1349
 2
 GOVERNMENT OF MADRAS.
 LOCAL AND MUNICIPAL DEPARTMENT.

NOTE by the Chief Engineer, Public Works Department, on G.O., dated 11th March 1891, No. 349 M.

Mr. Jones' scheme for the improvement of the Cooum consists of two parts, which may conveniently be considered separately.

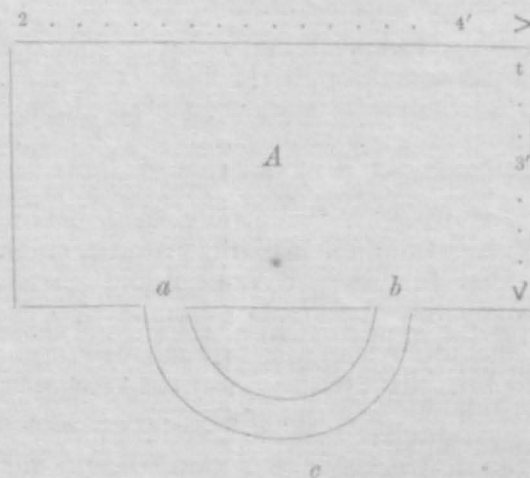
13. Admission of tidal water, and its emission by the same outlet, will produce oscillation, but not, or only to a very trifling extent, circulation. A very simple experiment will show this:—

A is a good-sized tank 12 inches deep and $a b c$ a curved trough of the same depth connected with the tank at both ends. If the tank be filled to within about six inches of the top and some light material such as sawdust sprinkled over the surface of the water in $a b c$, and the tank then alternately filled to the brim and emptied to six inches from it, it will be found that there is next to no movement of the sawdust, and this will be the case whether both ends $a b$ be kept open or one closed and the water admitted through the other; showing that there is nothing like real circulation in the trough $a b c$.

14. The condition is strictly analogous to that of the Cooum and proposed new canal connected with the harbour at one end and the sea at the Napier Bridge at the other.

15. If instead of keeping one or both ends of the trough permanently open, we now close the end b while the tank is being filled, and while it is being emptied close both ends until the water has fallen three inches and then open b , it will be found that a decided current is produced from a towards b and that after a few "tides," the whole of the floating sawdust will have been carried out through b into the tank.
